Remarks/Arguments

Solar heat transfer system (HTPL), high temperature pressurized loop

Appl. No. 10/085,175
Request for Continued Examination
Final Office Action Dated August 07, 2009
Due October 07, 2009

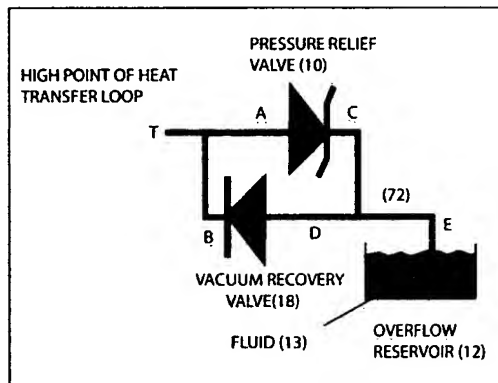
Paragraph 2 of the office action of 07/07/2009, rejected Claims 1-3 and 13 as not being described in the filed specification. Specifically stating that “accommodating thermal expansion and contraction or displacing air with fluid . There is no mention of such in the specification as originally filed.”

Paragraph [0018] shows that the invention as claimed was described and included in the original application. fluid thermal expansion “**the heat transfer fluid expands as it heats from 75 degrees Fahrenheit to over 230 degrees Fahrenheit**”, fluid thermal contraction” **the fluid in the solar heat transfer system cools and contracts**” and air displacement “**fluid is drawn back into the heat transfer system to keep it full of fluid and keep air out**”.

[0018] The invention also consists of a pressure relief and fluid overflow recovery system (FIG. 2). and includes a pressurized fluid reservoir (3), a pressure cap to regulate the pressure in the system, and allow the overflow to return on system cool down at night (2), which is connected to a fluid overflow and recovery reservoir (4). The pressure of the fluid in the solar collector heat transfer loop is regulated by the pressure cap, which uses a spring to push against the fluid pressure over a fixed area. During normal daily operation when the sun is out, the heat transfer fluid expands as it heats from 75 degrees Fahrenheit to over 230 degrees Fahrenheit and when the pressure reaches the set pressure, i.e. 16 PSI, fluid overflows to the fluid overflow reservoir (21), which is vented to the atmosphere by a cap (30). At night, when the fluid in the *solar heat transfer system* cools and contracts, fluid is drawn back into the heat transfer system to keep it full of fluid and keep air out. Air in the system increases the corrosion of the fluid loop. This simple system allows the approximately 50% water/50% antifreeze mixture in the solar heat transfer loop to heat up to over 212 degrees Fahrenheit, without boiling until it reaches almost 265 degrees Fahrenheit, at 16 PSI confinement pressure. This high temperature allows for heat to be transferred more efficiently into the hot water tank, using lower flow rates and an internal (or external) hot water tank heat exchanger.

CLAIMED BY BUTLER IN HIS FIGURES 2, 6, 7, 8 & 9

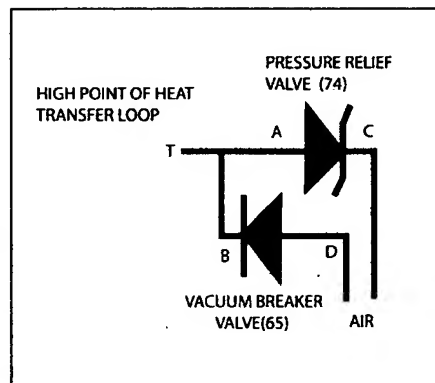
Paragraph 7 of the office action of 07/07/2009 rejected Claims 2, 3, and 13 as being anticipated by Hardy (4,360,003). I have carefully reviewed the cited patent and believe that my claims are not anticipated by Hardy (4,360,003). Hardy recites a Vacuum Breaker Valve (65) which is defined as a one way valve which lets air into a system when the pressure in the system goes below atmospheric. I recite a vacuum fluid recovery valve

I have drawn the schematic pictures of my claimed configuration and Hardy's side by side so the differences can be clearly shown. I recite in Figure 2, 6, 7, 8 & 9 a pressure relief valve (10) and a vacuum fluid recovery valve (18), which are in parallel, but both are connected to Overflow Reservoir (13), below the fluid level by pipe (72). In Hardy's arrangement the pressure relief valve 74 discharges water/steam into the air and onto the floor and the vacuum breaker valve 65 draws only air back into the closed loop to prevent boiler reservoir non-potable water backflow into the domestic water fluid loop through float valve 69. I submit that Hardy has parallel pressure relief 74 and vacuum "breaker" relief 65 valve which go from the fluid loop to the atmosphere, which is fundamentally different from the parallel pressure relief (10) and vacuum "fluid recovery" relief (18) valves which go from the fluid loop to below fluid level in the overflow reservoir (12) which I have recited, hence Hardy has not anticipated my invention. In my Figure 2 above A, B & T are all tied together. The same is true for Hardy's Figure 2 above. In my patent application C & D are tied to E, which extends below the fluid level in the overflow reservoir (12). In Hardy's patent, C & D are not tied together and each vents separately to the air. The vacuum breaker (65) pipe D allows air to enter the loop if it is un-pressurized. The pressure relief (74) pipe C allows water and steam to escape, to the air, but will not let any fluid back into the heat transfer loop.

I recited a vacuum fluid recovery valve (18), which is not the same as Hardy's vacuum breaker valve 65. Both valves fall under the general category of vacuum relief valves. A vacuum fluid recovery valve (18) has its inlet below the water level of a fluid reservoir. **My Specification, DETAILED DESCRIPTION OF PREFERRED EMBODIMENT, Par. 1, lines, 9-11** "to a pressure relief valve (10) which includes a vacuum recovery valve to let expelled heat exchanger fluid (13) back into the system from the fluid overflow/recovery reservoir (12), while excluding non-condensable air." A vacuum

breaker valve **65** must have its inlet open to air to prevent contamination of domestic water with non-potable water. **Hardy col. 5 lines, 5-11** "Placed on inlet **64** is vacuum breaker **65** such as a vacuum relief valve of conventional construction and as commonly commercially available from sources such as from Hardy Manufacturing Company, Inc., Route 4, Box 156, Philadelphia, MI 39530 and others, the breaker to prevent accidental siphoning of tank water into the home water supply". I submit that Hardy has a vacuum breaker valve **65** on his domestic water loop, since its function is fundamentally different from the vacuum fluid recovery valve (18) which I have recited, hence Hardy has not anticipated my invention..
